Our Case Number: ABP-311315-21

Re: Park development project at the Racecourse Park
Located between Baldoyle and Portmarnock, Co. Dublin

Date: 26th October 2021
Our ref: 3237/21
Your ref: JP06F.311315

Re: Proposed Park Development Project at Racecourse Park between
Baldoyle and Portmarnock.
Applicant: Fingal County Council.

Figure 1. Land adjacent to UBB19

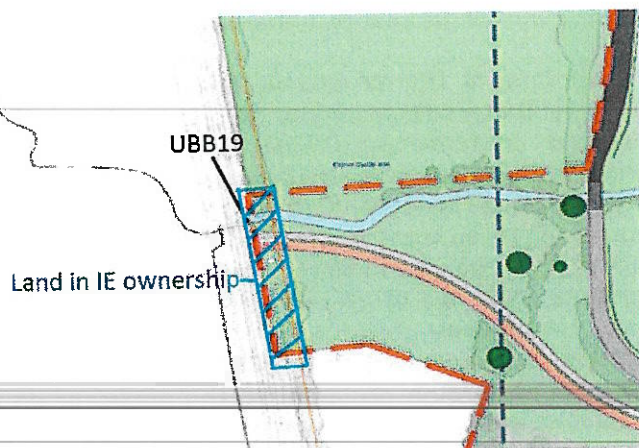
5) We note that it is proposed to connect a walking and cycling network in the development with the Dublin City Council lands at Clongriffin on the west side of the railway line. The Planning application drawing 'DN1815-101 Landscape Masterplan' incorrectly shows the extent of Council ownership (refer to Figure 1. below) adjacent to UBB19.

It must be noted that the approach and embankments to Railway Bridge UBB19 are in full ownership of CIE. This is clearly set out in Section 46 of

the Railway Clauses Consolidation Act 1845. Formal consent in writing must be sought for the inclusion of lands in CIE ownership in the planning application. Any works proposed to the approach road, embankments and to the bridge including resurfacing, minor repair and laying of ducts or services etc will require a licence from CIE/Irish Rail.

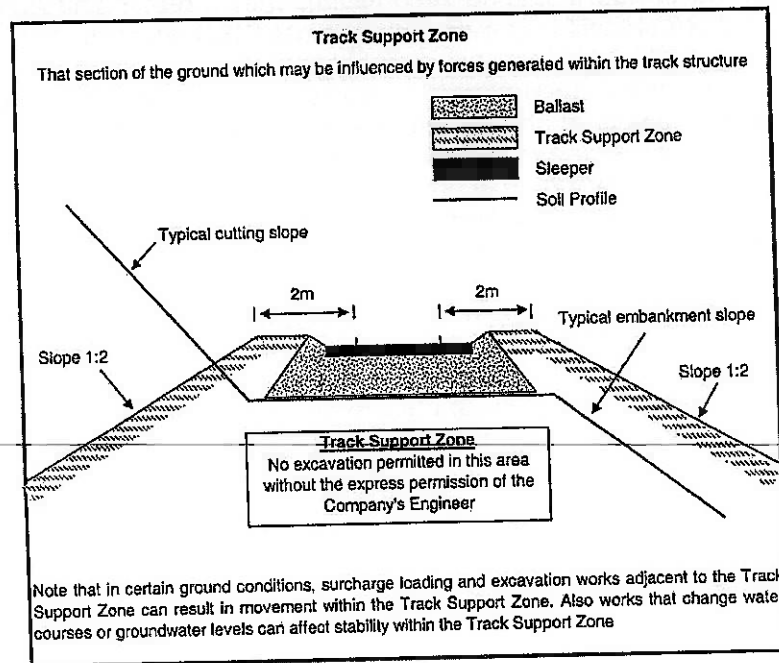
- 13) Any excavations which infringe upon the Track Support Zone will require permission and approval from the Senior Track & Structures Engineer. This relates to all excavations along the railway boundary for this development.
